CONFIRMATION
MEMO

PROJECT JO HERDT ADDITION DATE 2-6-84
JOB NO. _____
TO Chris Breitenstein
FROM N. Brent Wooten
REFERENCE Final Drainage Plan

drainage plan 1-5-84

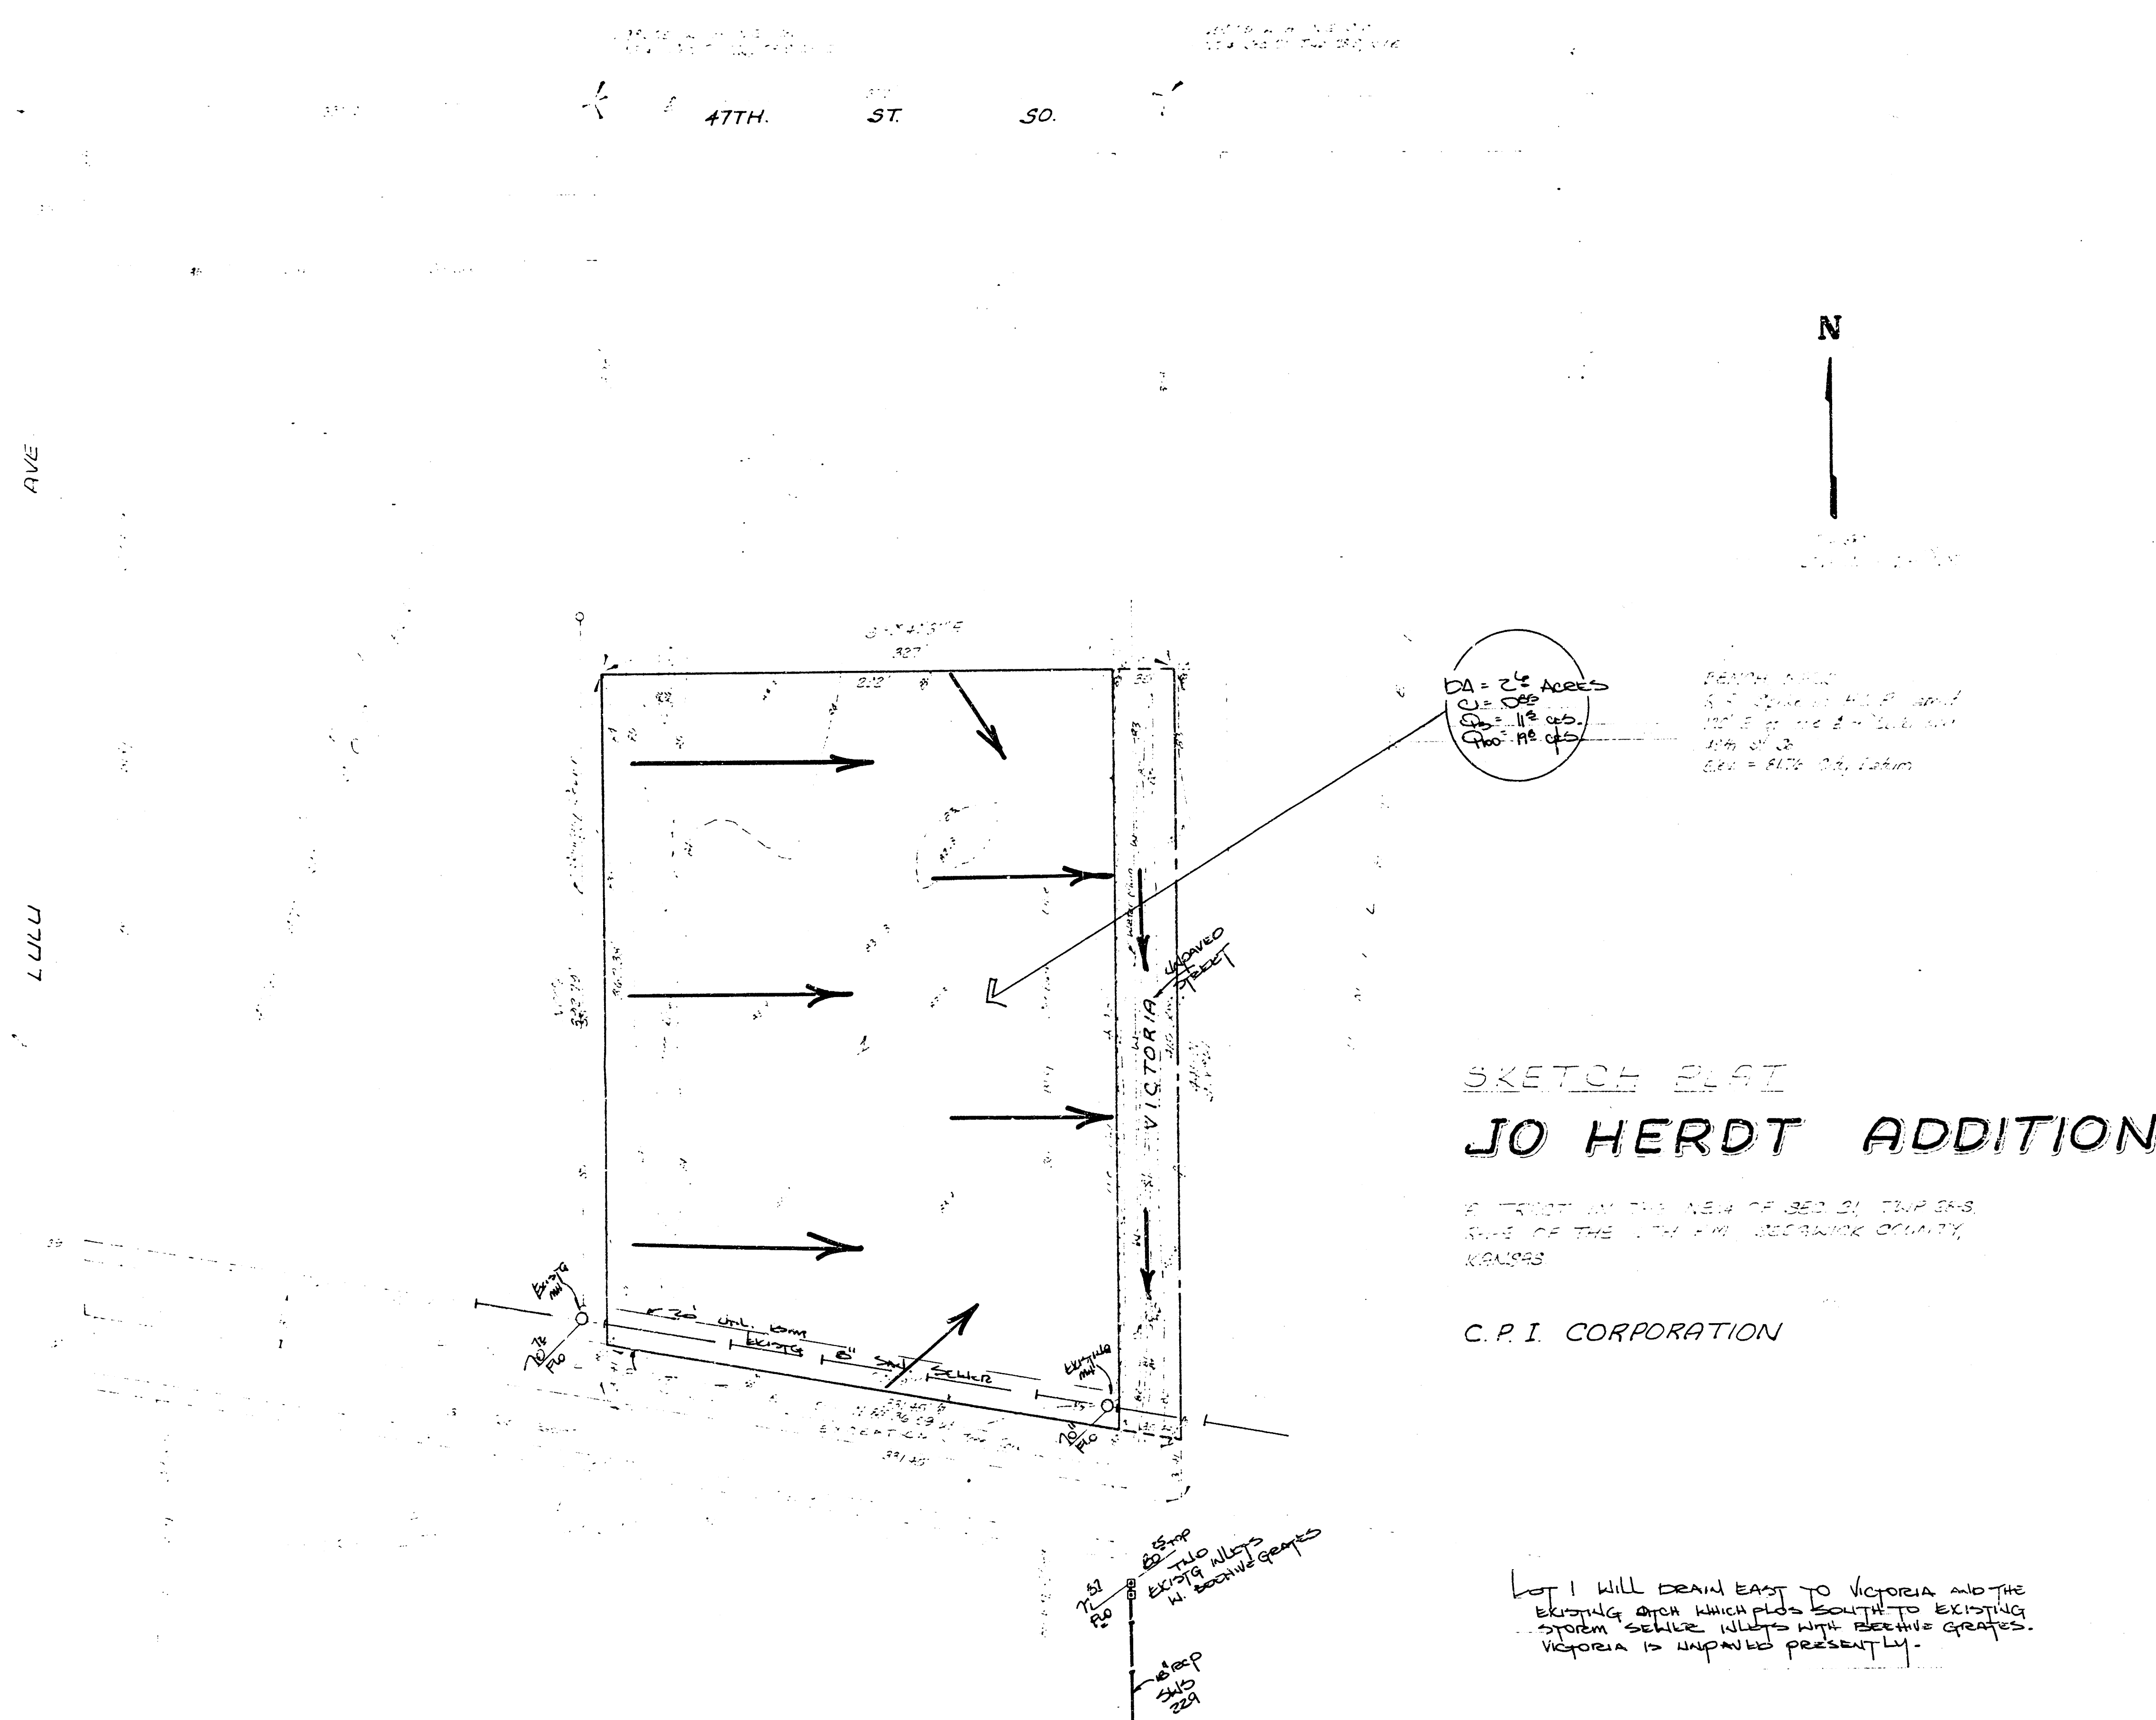
Draw to unpaved st.

B+C) drain to unpaved st.

OK with O+N?

Do we require guarantee to pave adjacent to plat?
